Amendments to the Drawings:

REMARKS/ARGUMENTS

Appl. No. 10/037,278
Amdt. dated January 3, 2006
Reply to Office Action of September 2, 2005

FIG. 1F

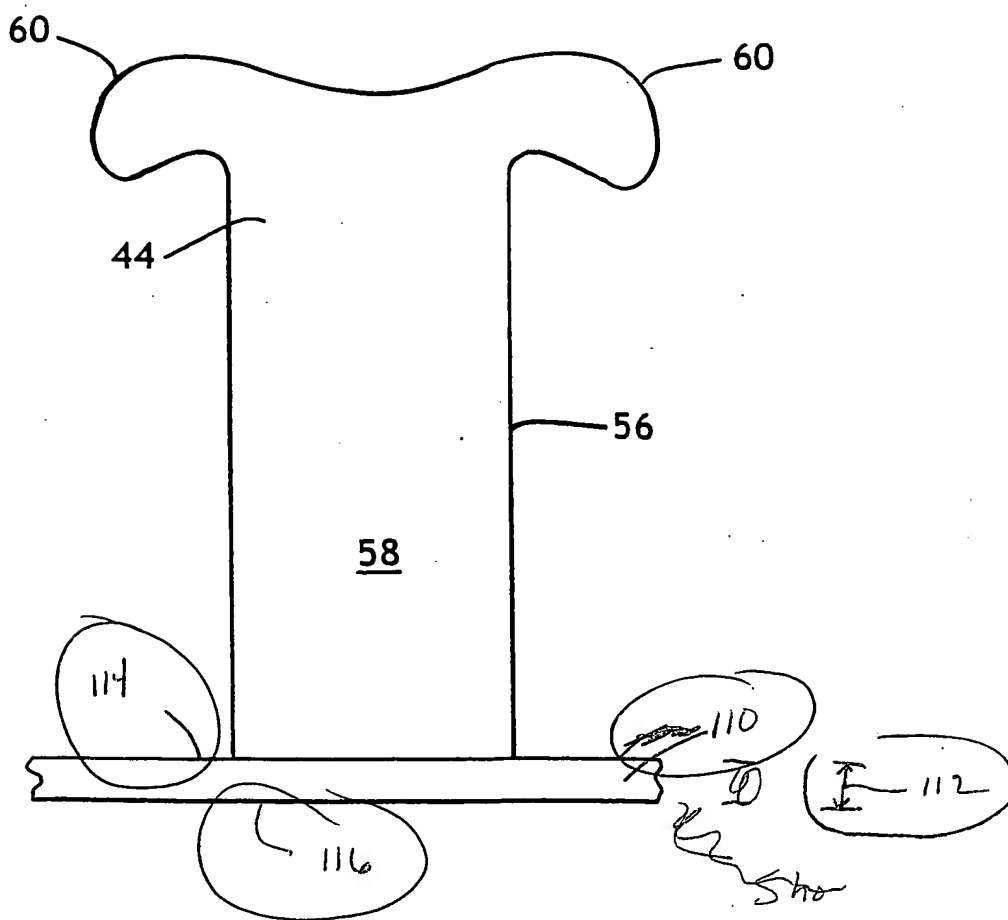
Regarding Fig. 1F, Applicants have resubmitted Fig. 1F and have deleted reference numerals 11, 12 and 13. In addition, the left flap has been relabeled 36' and the right flap has been relabeled 36, at the Examiner's request. Further, the specification at page 5 has been amended to state that Fig 1F shows a cross-section.

On page 4 of the Office Action, the Examiner objects to the drawings under 37 CFR 1.83(a) on the basis that the drawings do not show the sheets, the core and the perforation lines. The Examiner's attention is directed to Fig. 1F, which clearly shows the top sheet, the backsheet and the absorbent core. Therefore, these features are clearly shown by the drawings. In addition, Figs. 1D and 1E show the perforation lines 71 and the corresponding text in the specification at page 9, line 20, et seq. was amended to indicate that Figs. 1D and 1E show perforation lines 71. Therefore, the Examiner's objection to the drawings under 37 CFR 1.83(a) is improper, since the noted features are shown in the drawings.

FIG. 2A

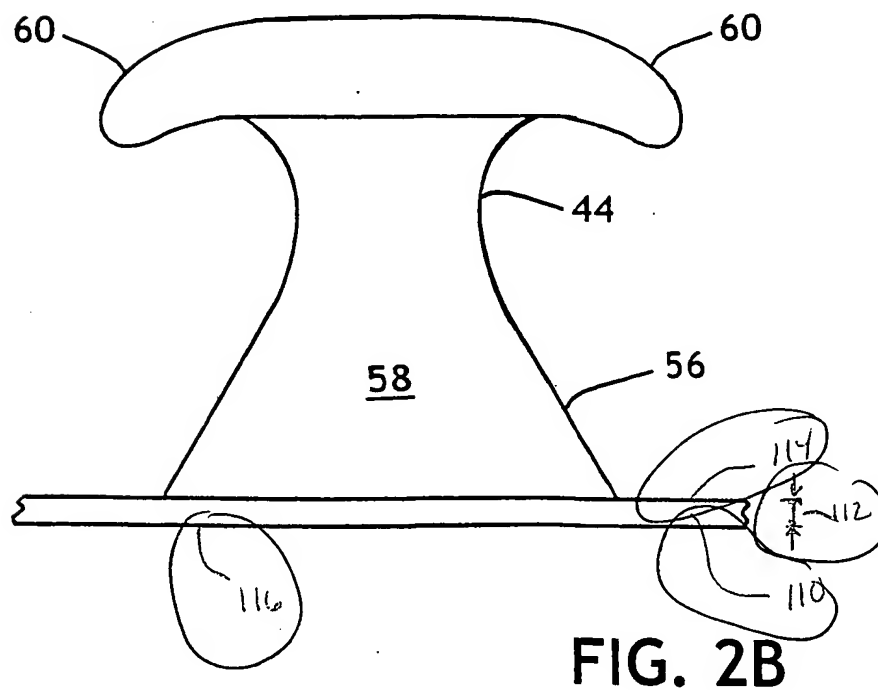
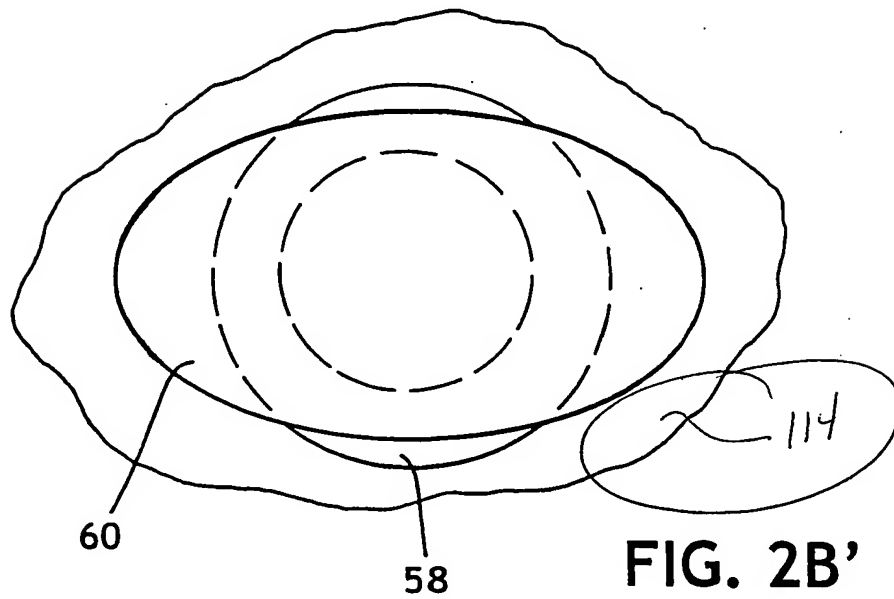
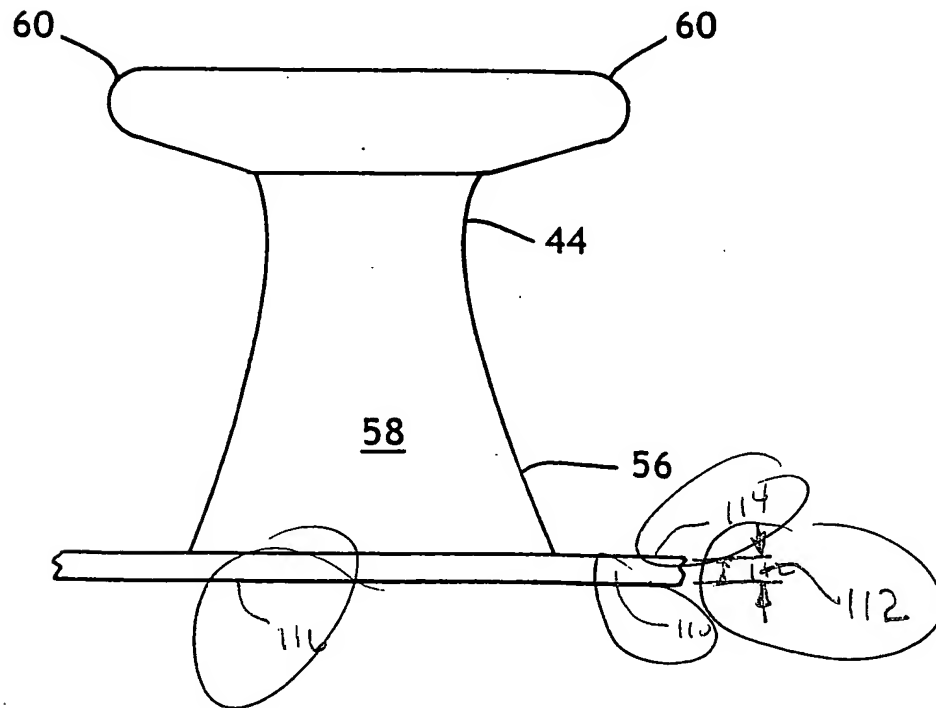
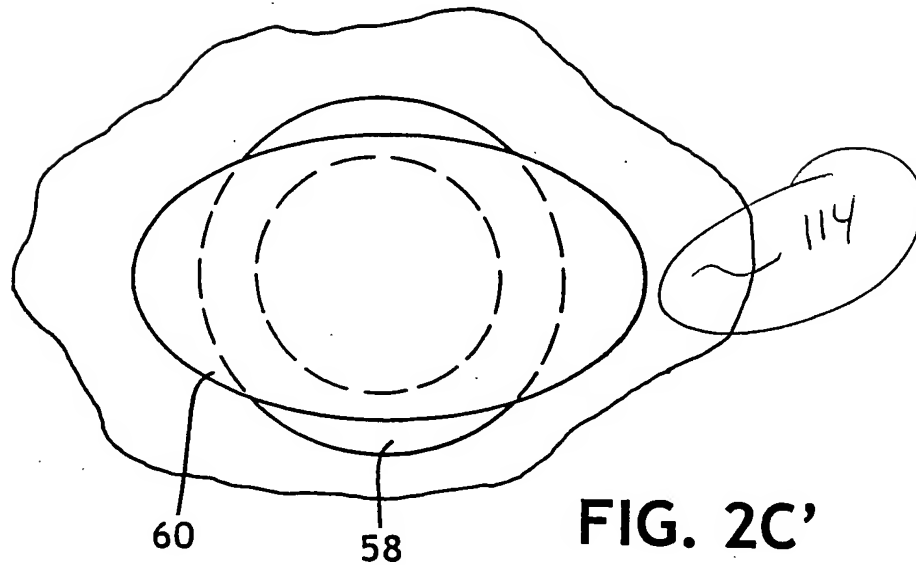
The Examiner also states in the Office Action that the submitted drawings did not include replacements sheets for Figs. 2A-2C'. Applicants have included new replacement sheets for Figs. 2A-2C', as well as the annotated figures previously submitted.

The Examiner also finds that elements 110, 112, 114 and 116 are not shown in Figs. 2A - 2E as described in the paragraph on page 13, line 16. Applicants again direct the Examiner's attention to the Amendment filed July 28, 2004. This paragraph was amended to refer to Figs. 2A-2C' and does not refer to drawings 2D or 2E. Figs. 2A - 2C', which are attached hereto, show each of elements 110, 112, 114 and 116, as set forth in this paragraph, as it is currently amended.

FIG. 2D

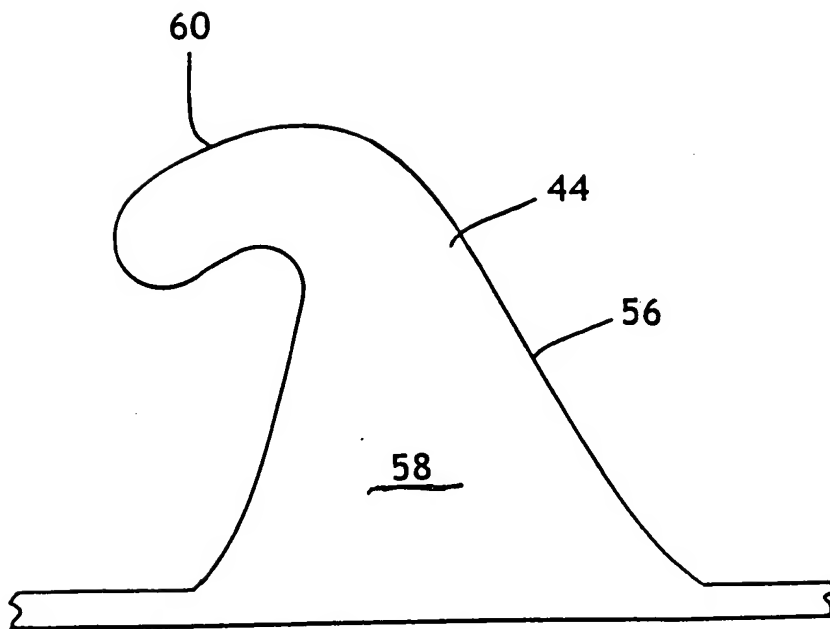
Regarding Fig. 2D, the attached correction to Fig. 2D underlines element 58. Hence, this objection should be overcome.
